REVISED RESPONSE TO REQUEST FOR ADDITIONAL INFORMATION

APR1400 Design Certification

Docket No. 52-046

RAI No.: 45-7883
SRP Section: 07.09 – Data Communication System
Application Section: 07.09
Date of RAI Issue: 06/23/2015

Figure 4-1 APR1400 I&C System Overview Architecture

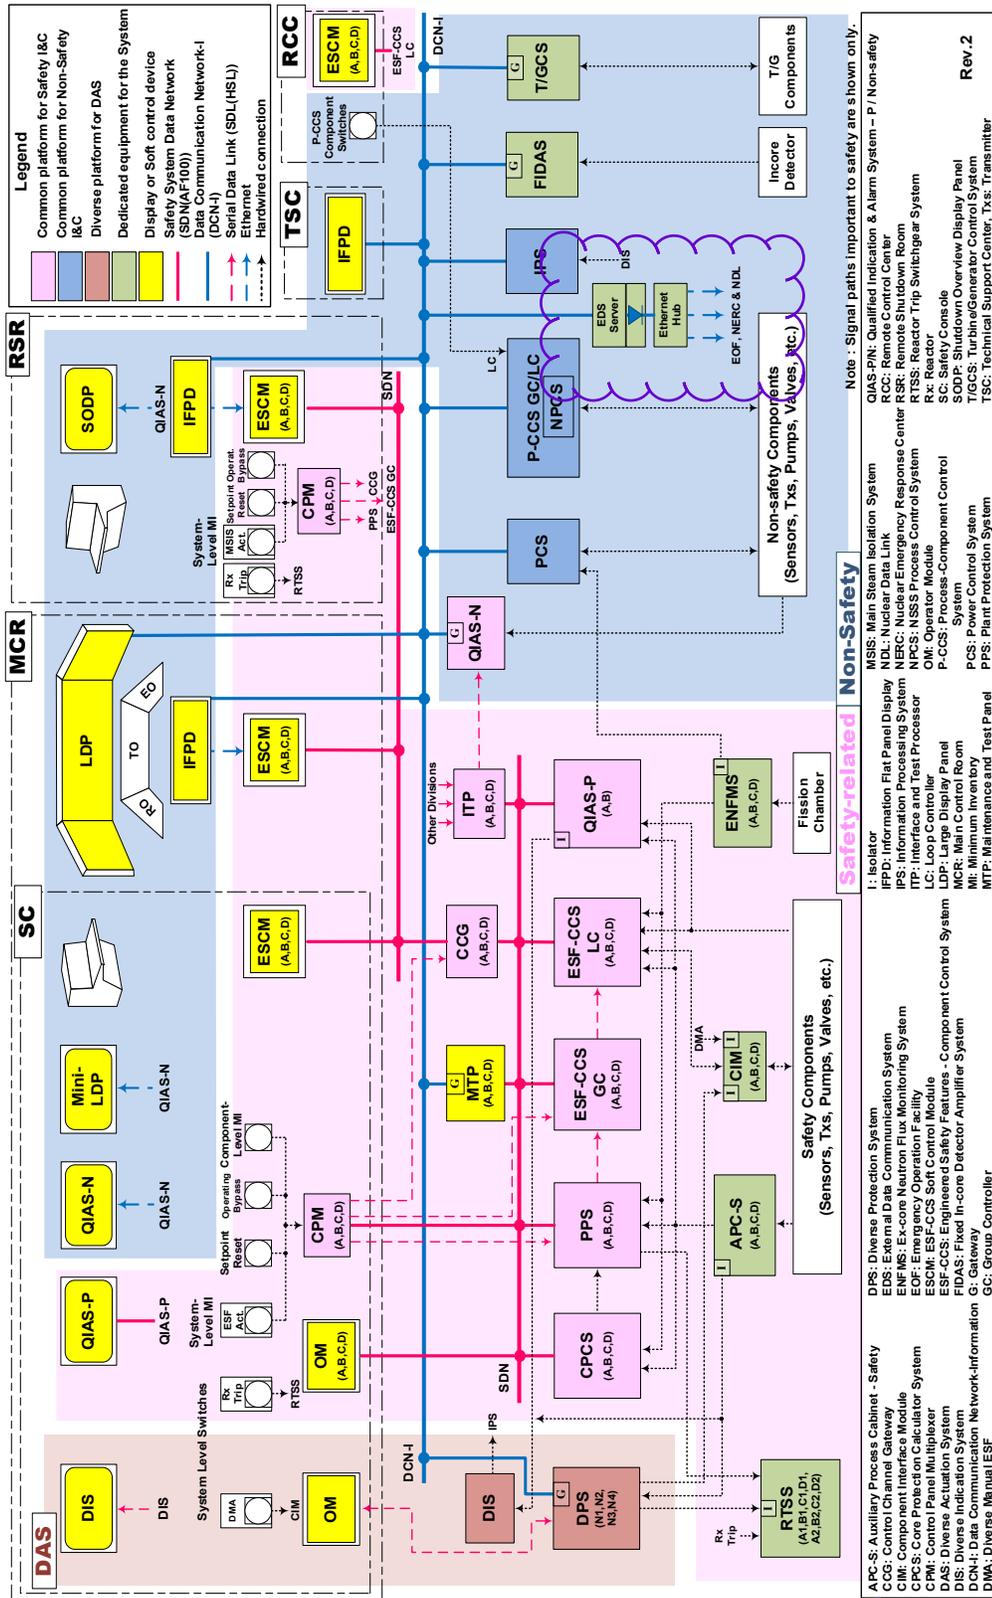
A description of the communication with external interfaces, such as the Emergency Operations Facility, will be revised by a new Section 4.6.2.7. The corresponding interface will be revised in Figure 4-1 of the Safety I&C System Technical Report, Figure 4-1 of the Diversity and Defense-in-Depth Technical Report and Figure 7.1-1 of the DCD Tier 2.

Sections 4.6.2.7 and Figure 4-1 of the Safety I&C System Technical Report will be revised as indicated in the attached mark-up.

Figure 7.1-1 APR1400 I&C System Overview Architecture

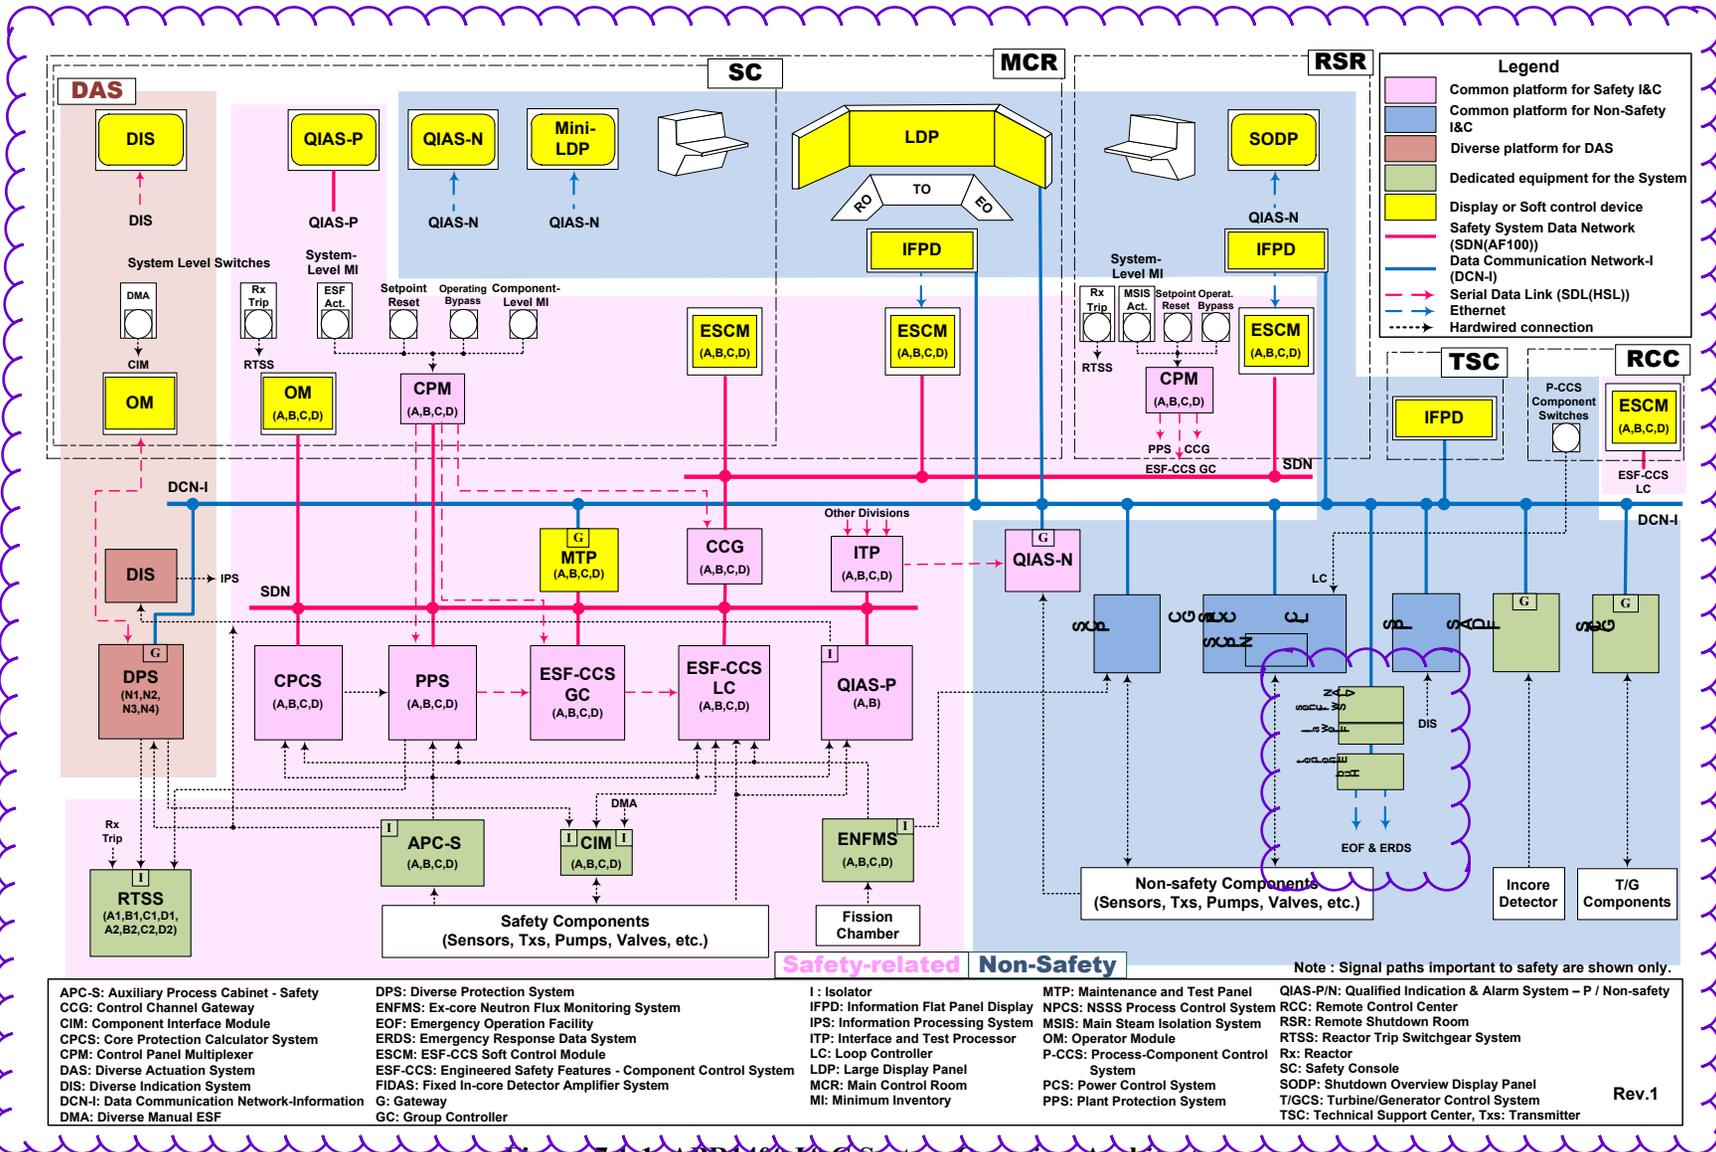
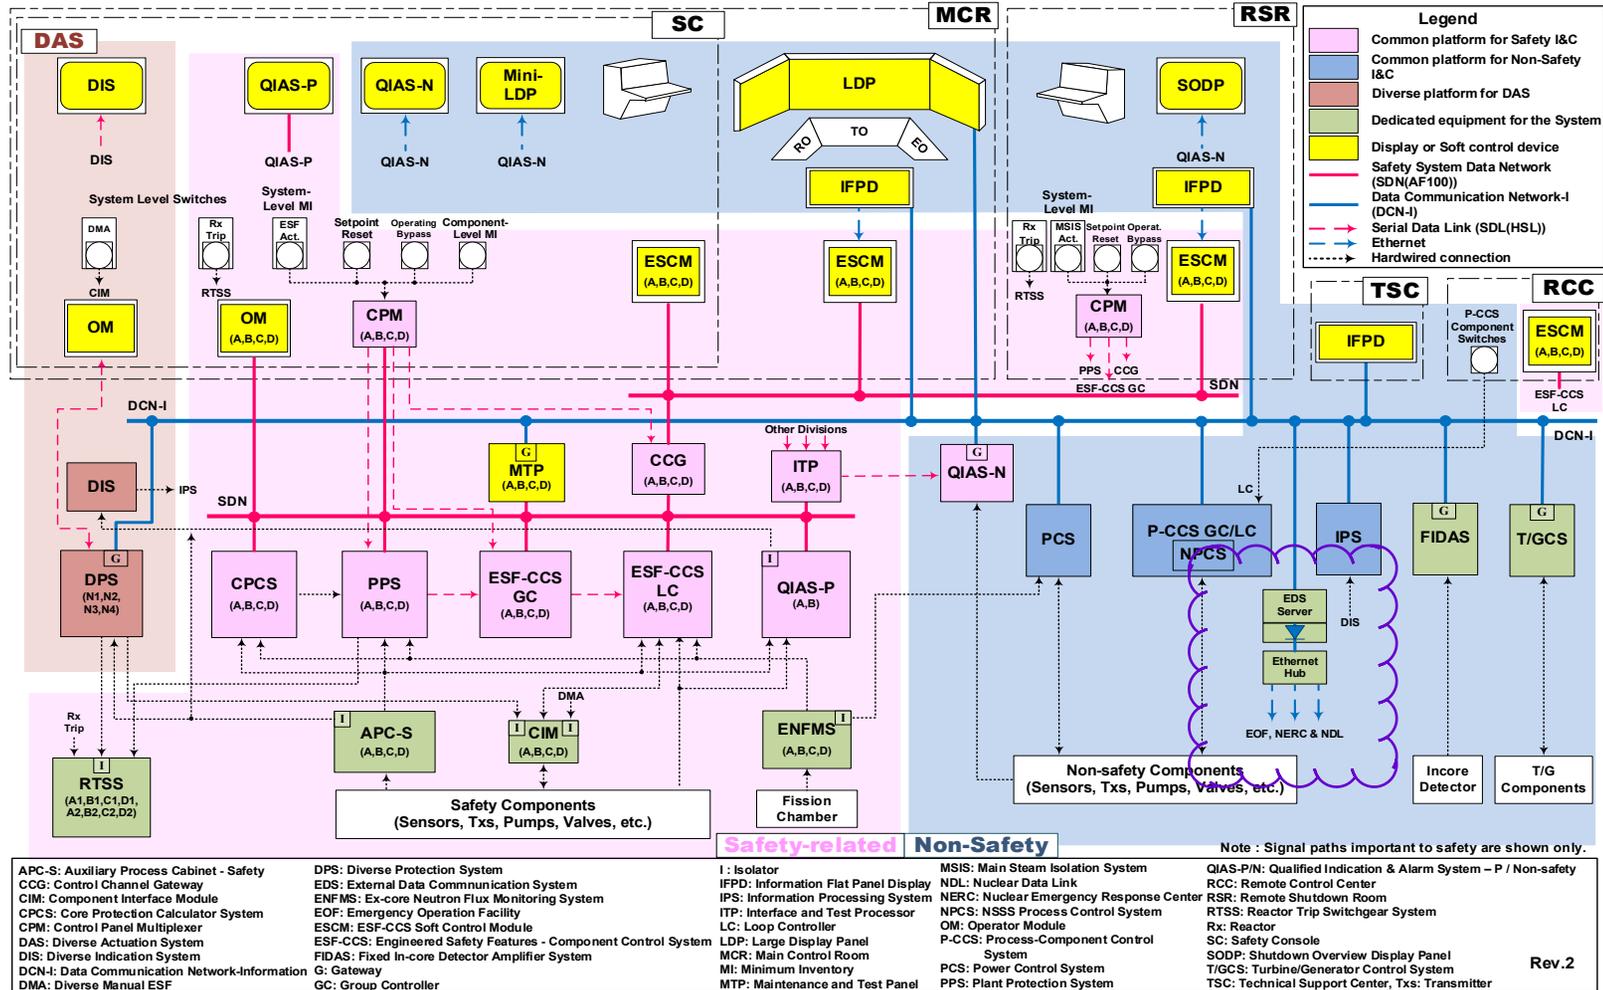
Figure 7.1-1 of the DCD will be revised as indicated in the attached mark-up.

Replace "C" on the following page

Figure 4-1 Architecture Overview of the APR1400 I&C Systems

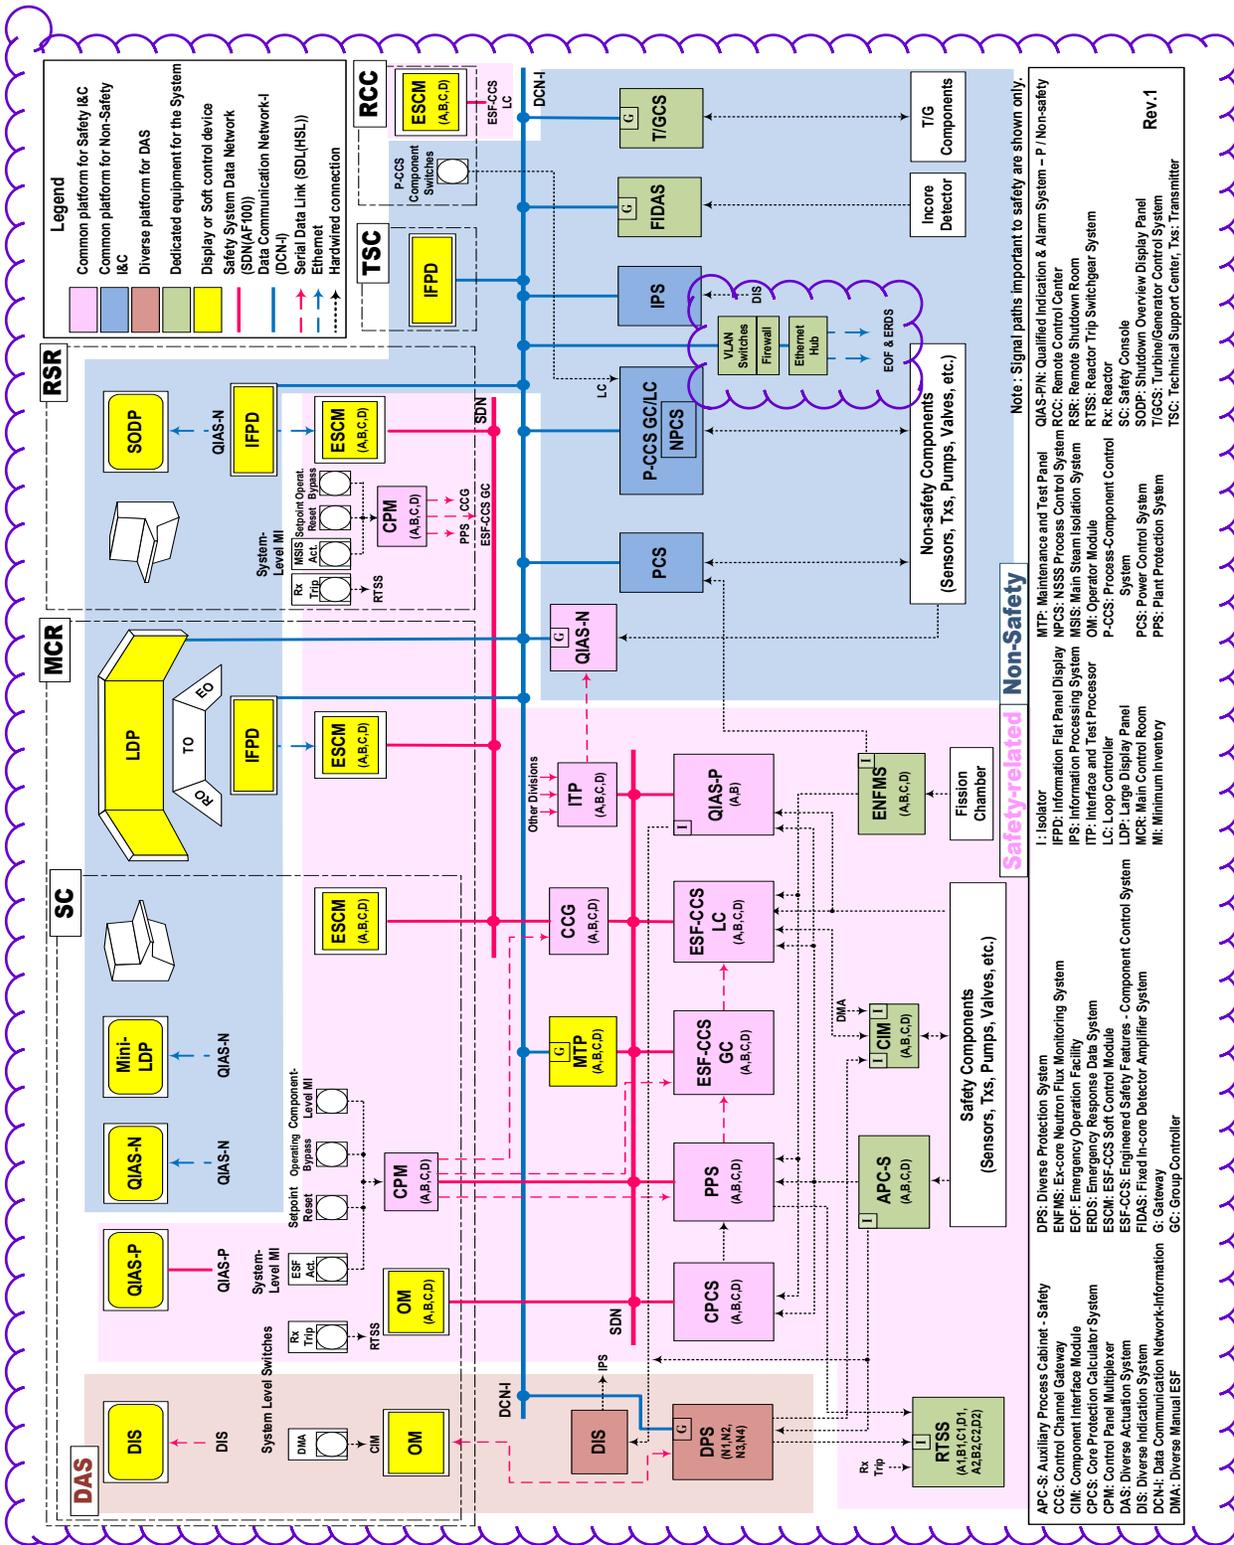
Figure 4-1 of the Diversity and Defense-in-Depth Technical Report and CCF Coping Analysis TeR will be revised as indicated in the attached mark-up.

Figure 4-1 Overview of APR1400 I&C System Architecture

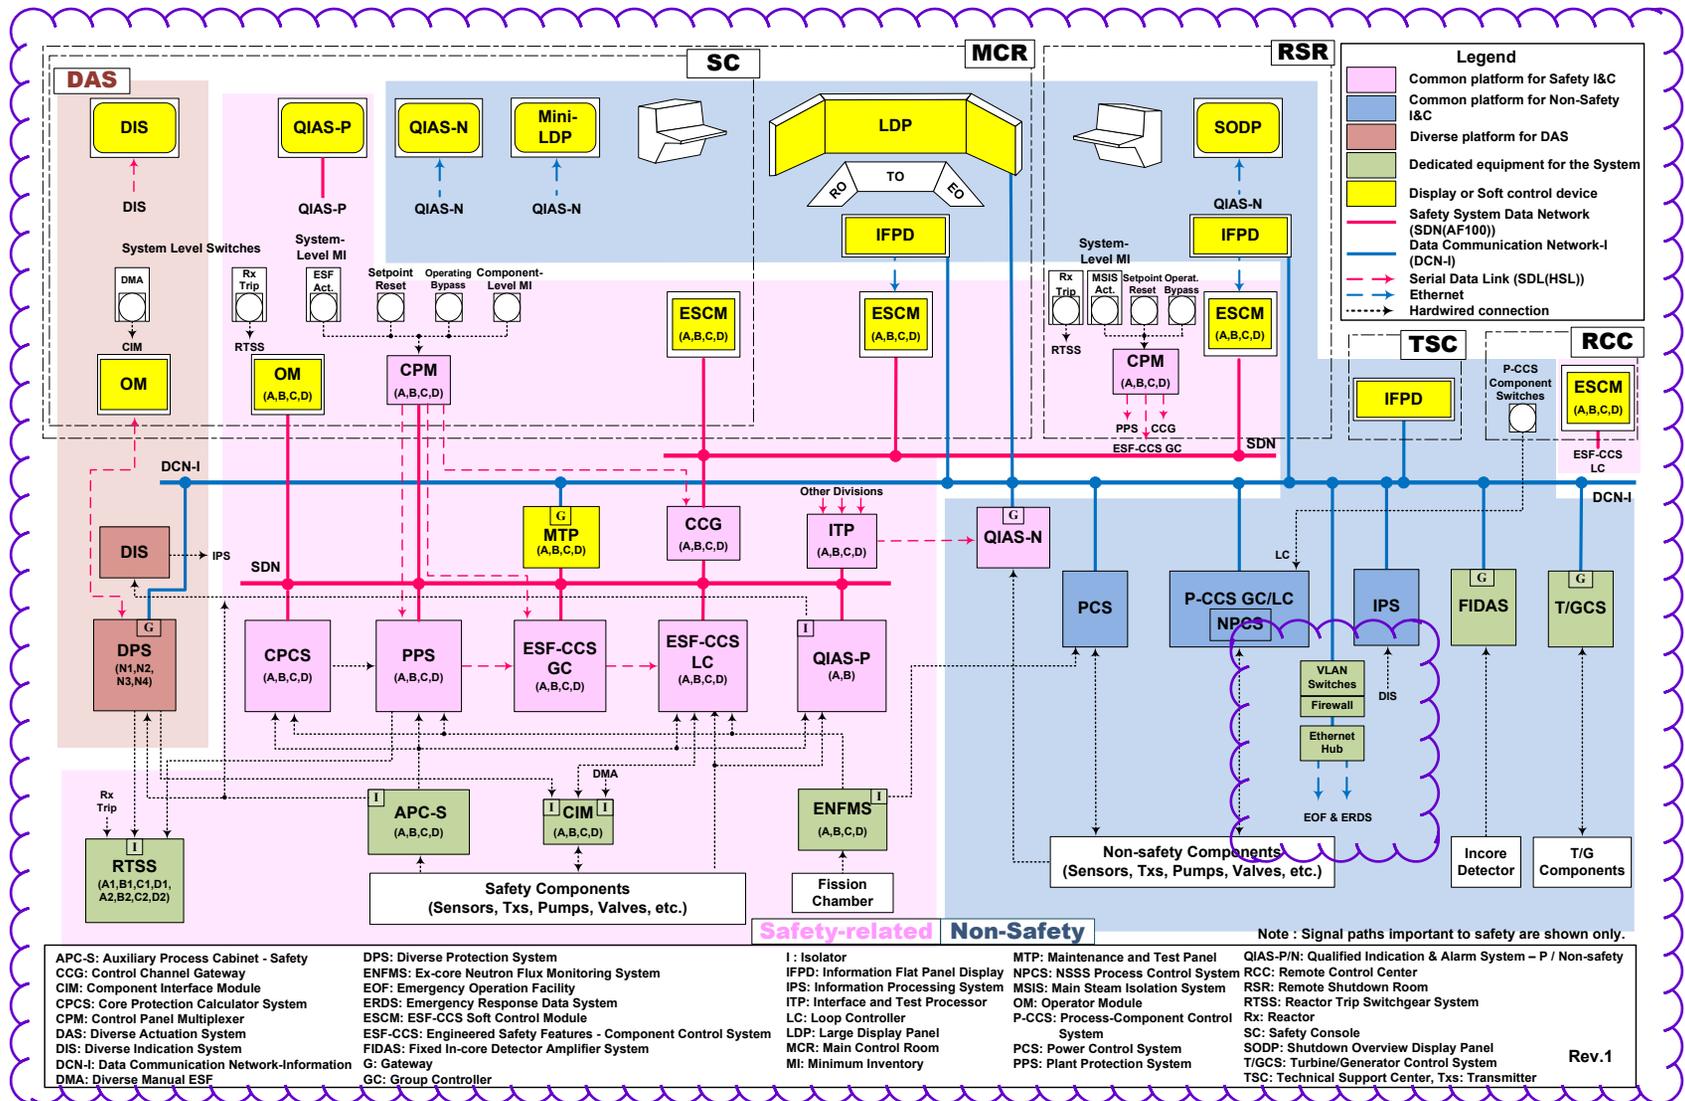
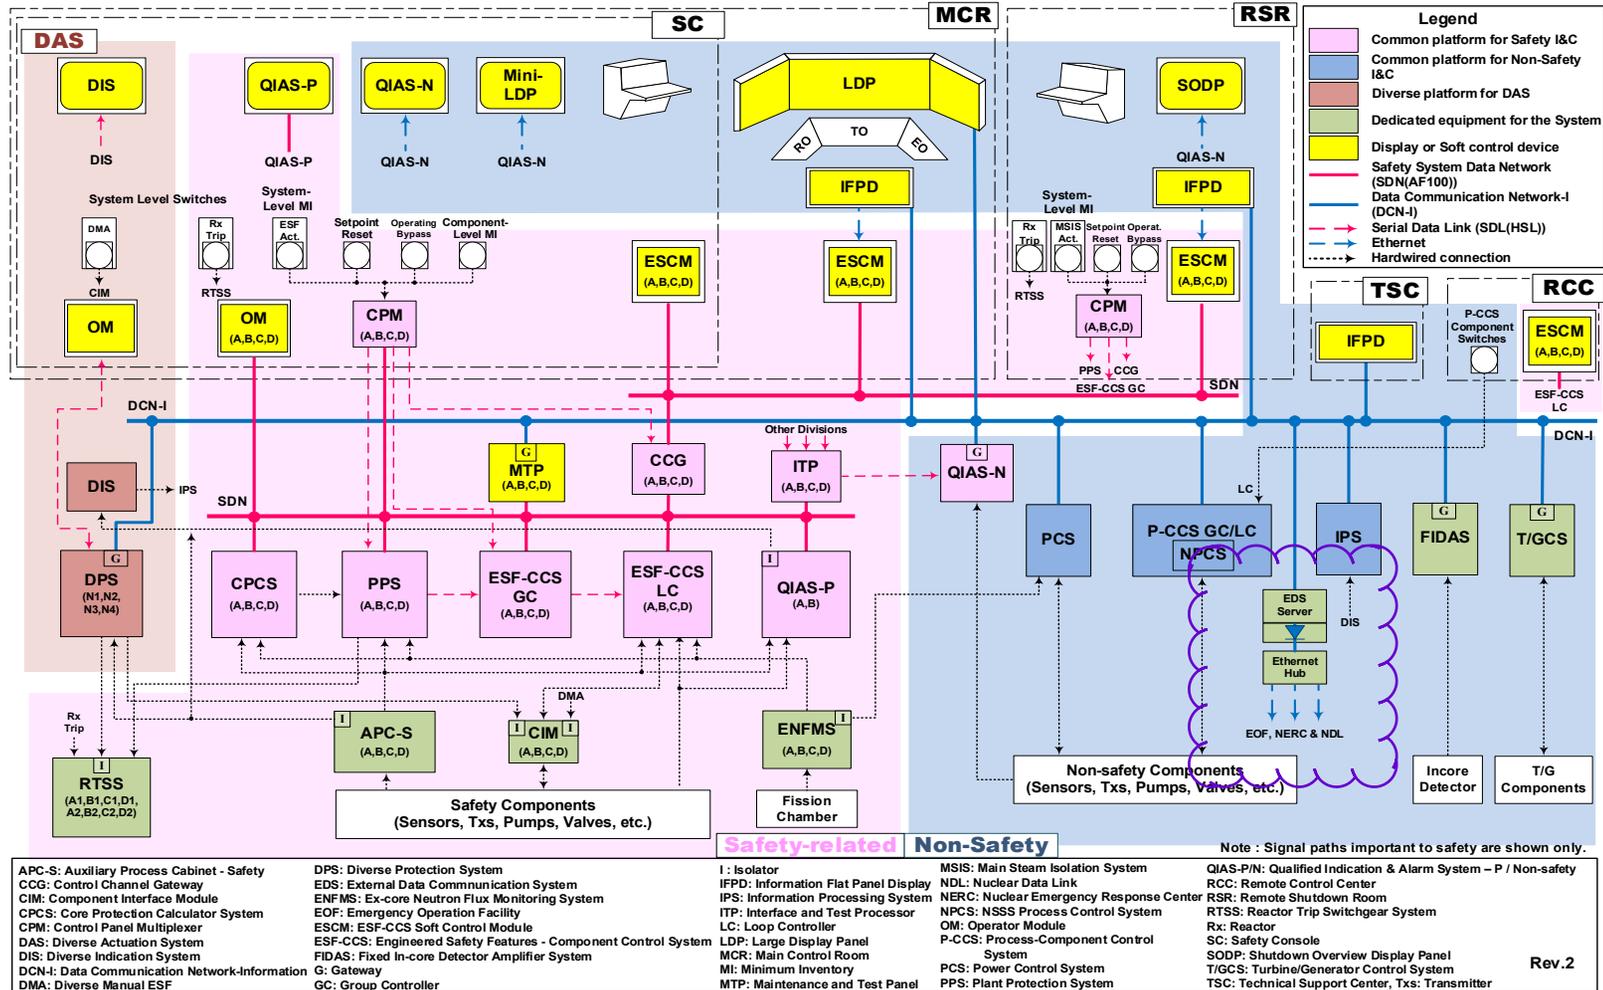
Replace "E" on the following page
